Addendum to the Supplement Environmental Impact Statement

Toms Gully Underground Project

July 2019

Figure 6-1: Aquatic Ecosystem Monitoring Sites.

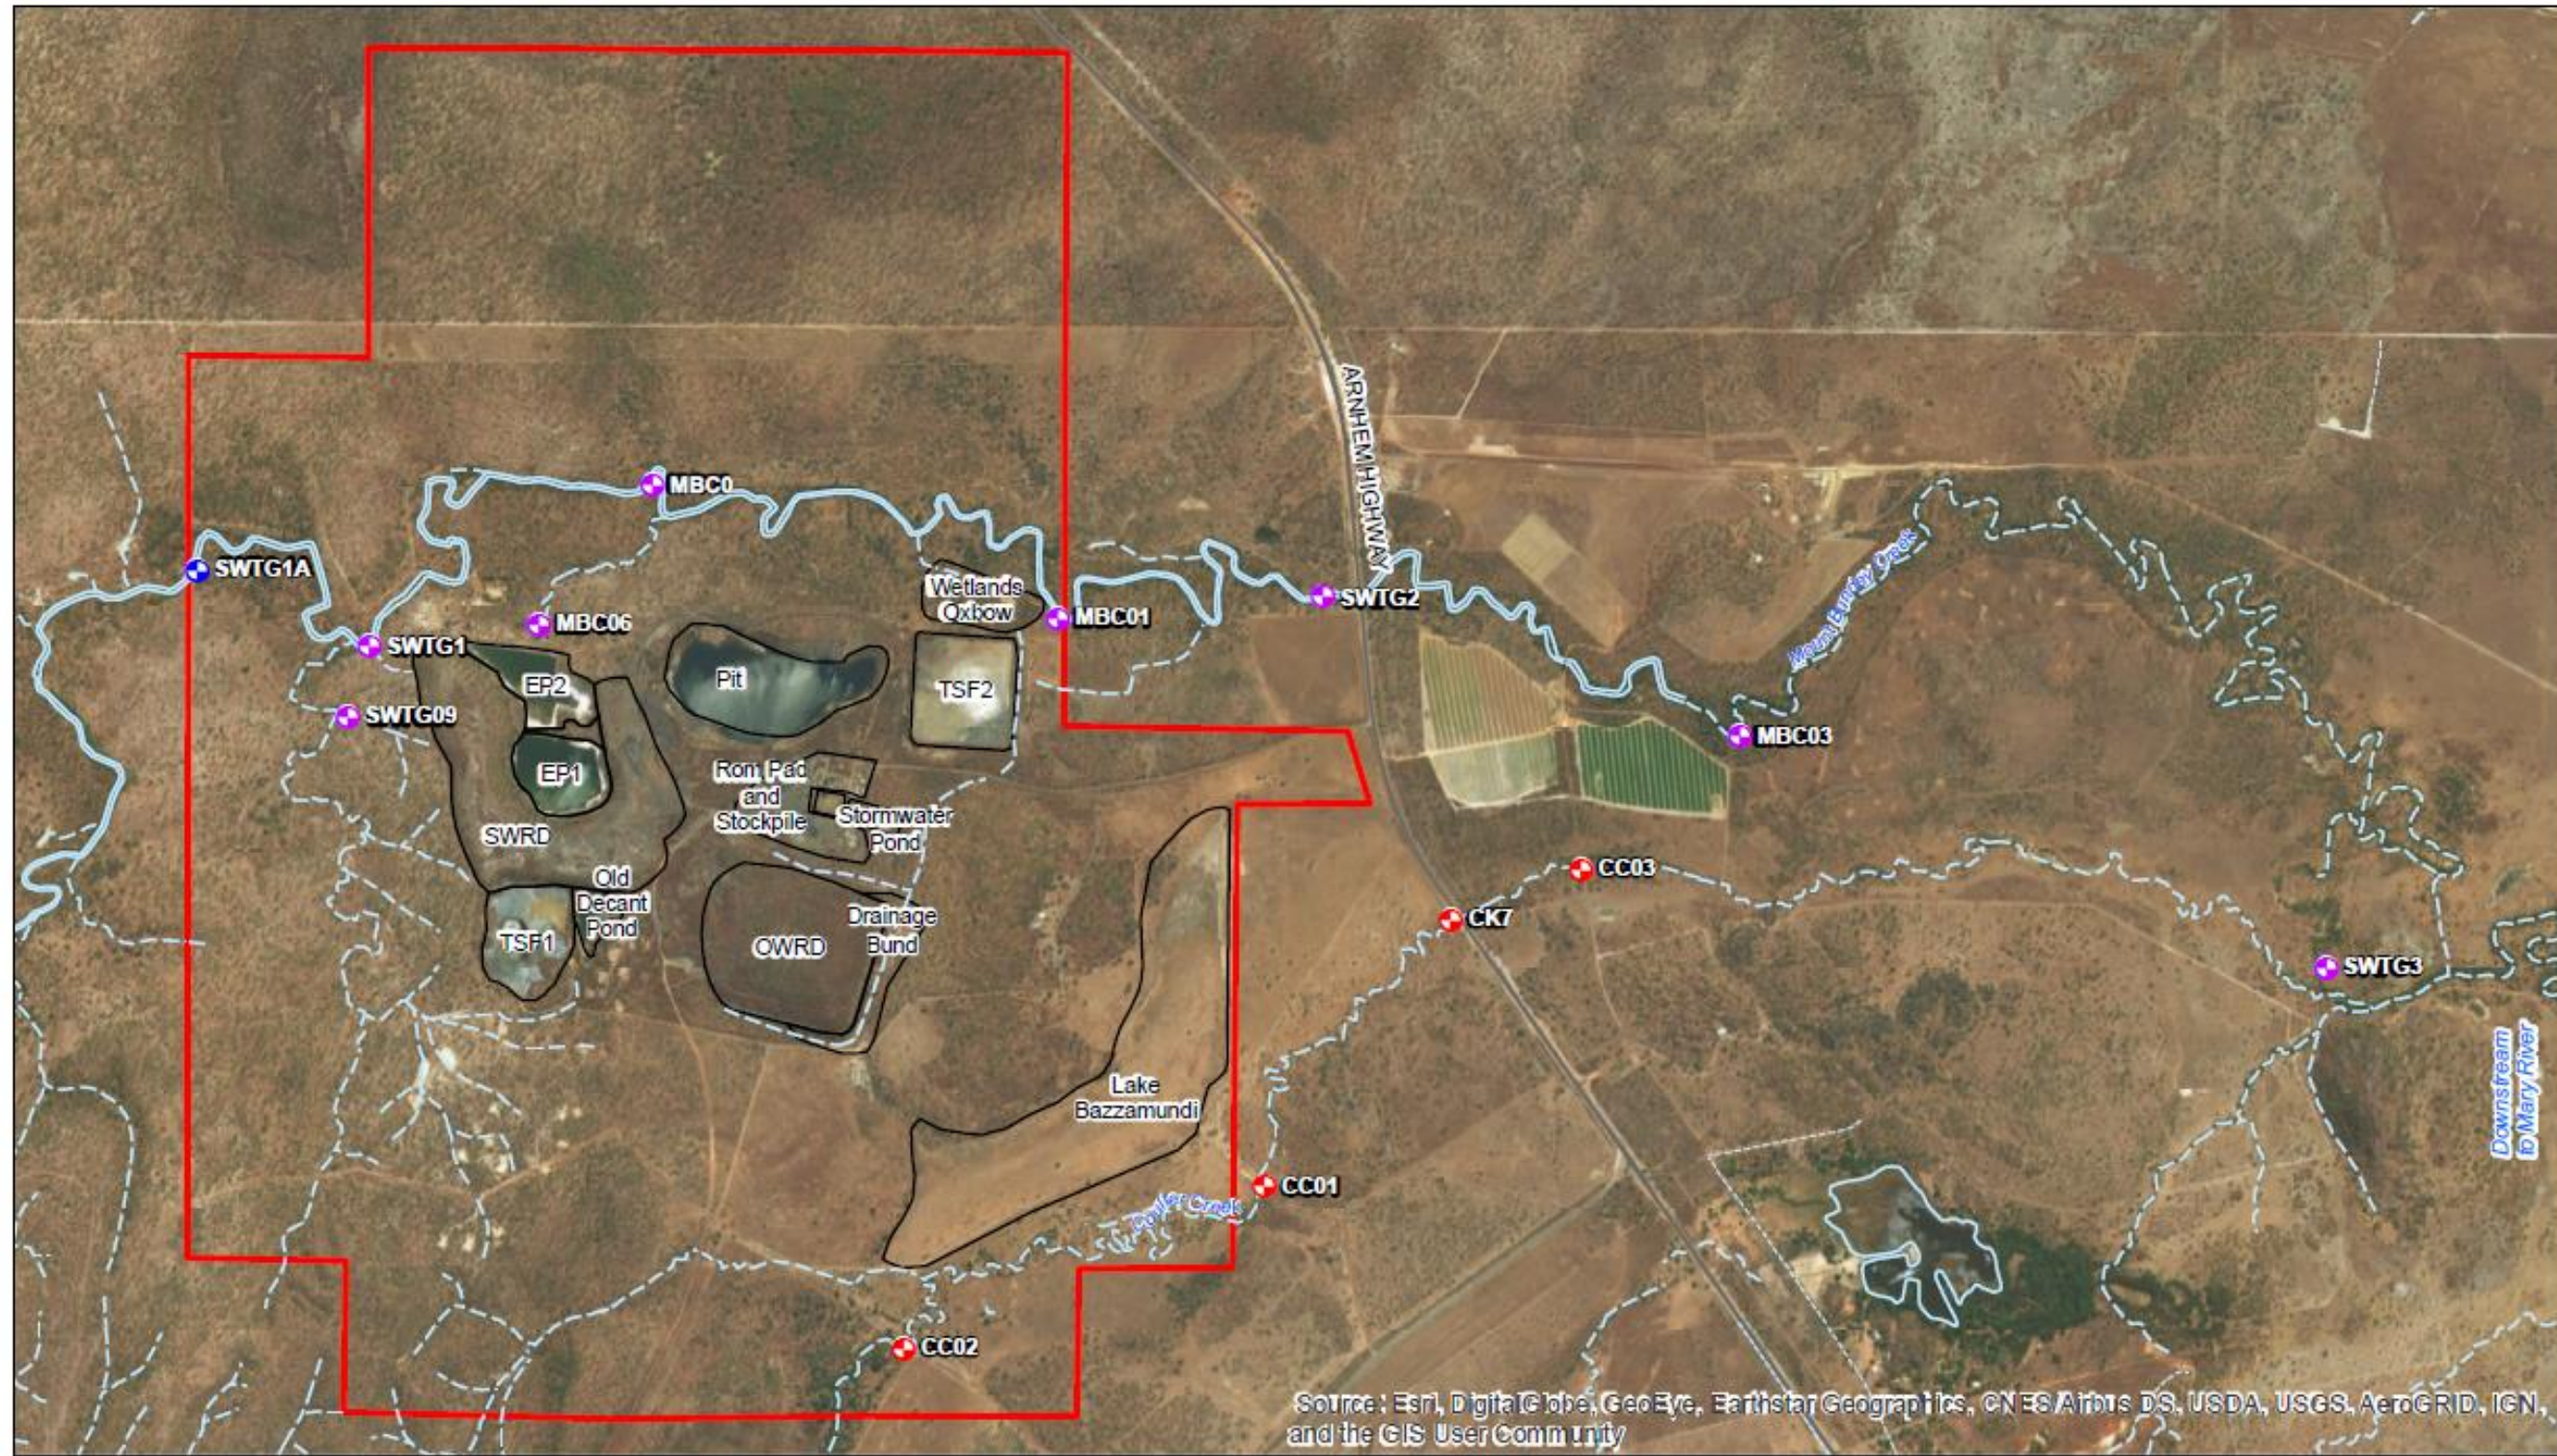
Comment 4 (First Request for Information – 5 September 2018)

Provide information on planned monitoring of aquatic ecosystem health during and after operations, including approach to selecting locations for monitoring, data to be collected, statistical analysis to be undertaken, and how resulting information may be used to detect any impact/s resulting from implementation of the Proposal.

Within the Draft EIS a commitment was given to undertake an annual aquatic monitoring survey. A survey was completed in 2015 as part of the Draft EIS (Appendix 4, Draft EIS) with the survey methodology modified to reflect regulatory feedback associated with the Draft EIS review. The updated methodology has been used for the surveys completed in 2017 (Appendix E, EIS Supplement), 2018 and 2019. During the restart, operations and eventual closure it is proposed to retain the sampling sites that are currently in use, the sites are presented in Figure 6-1. The retention and use of these locations is a function of and to provide the following:

steady state flows, water is shallow and clear enough to enter safely and conforms to protocols detailed in the Darwin-Daly AUSRIVAS Sampling and Processing Manual. Data to be collected during the surveys at each site will include:

- Condition and habitat description of each site;
- *In situ* water quality covering pH, electrical conductivity, water temperature, dissolved oxygen and turbidity;
- Laboratory analysis of water quality covering physio-chemical, cyanide, major anions and cations, and dissolved and total metal parameters;
- Aquatic macroinvertebrates sampling using AUSRIVAS protocols; and
- Fish sampling using backpack electrofishing, bait trapping and netting; and
- Camera trapping at selected sites to identify terrestrial fauna species that frequent areas around the site.
